Access Compliance Report

Public Rights-of-Way

(Curb Ramps)

Intersection ID: 29242	Main Street: MALLARD_FOREST_DR	Cross Street: PENSFOLD_DR	Location: SE
ADA ID: 395B1E6DEAB2	Ramp Type: PerpDiag	Initial Pass/Fail: Fail	Overall Compliance: No
Severity Score: 13.75			
Codes/Mitigation Info/Possible Solution		Field Measurements/Component Compliance

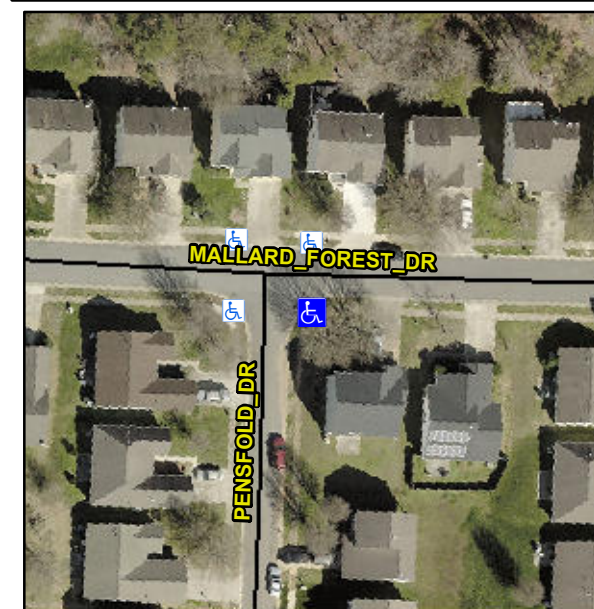
Not Found, R304.2.2, R304.5.3

Compliance	Description	Data	Compliance	Description	Data
N/A	Ramp Length (in)	47.0	No	Ramp Slope (%)	8.7
Yes	Ramp Width (in)	50.5	No	Ramp XSlope (%)	3.7
N/A	Flare Type LT	N/A	N/A	Flare Type RT	N/A
N/A	Flare Slope LT (%)	N/A	N/A	Flare Slope RT (%)	N/A
N/A	Flare Traversable LT?	N/A	N/A	Flare Traversable RT?	N/A
N/A	Landing Length (in)	N/A	N/A	DWS Provided?	N/A
N/A	Landing Width (in)	N/A	N/A	DWS Contrast?	N/A
N/A	Landing Slope (%)	N/A	N/A	DWS Length (in)	N/A
N/A	Landing X Slope (%)	N/A	N/A	DWS Full Width?	N/A
N/A	Landing Curb? (Y/N)	N/A	N/A	DWS Offset (in)	N/A
N/A	Shared Landing?	N/A			
N/A	Gutter Ponding?	N/A	N/A	Gutter Slope (%)	N/A
N/A	Gutter Lip Ht (in)	N/A	N/A	Gutter X Slope (%)	N/A
N/A	Painted X Walk1?	No	N/A	Painted X Walk2?	No
	X Walk 1 Direction	To N		X Walk 2 Direction	To W
N/A	X Walk 1 Width (in)	N/A	N/A	X Walk 2 Width (in)	N/A
	X Walk 1 Slope (%)	0.5		X Walk 2 Slope (%)	0.5
	X Walk 1 X Slope (%)	3.8		X Walk 2 X Slope (%)	6.7

Remove & Replace Curb Ramp With Two New Directional Ramps or Equivalent.
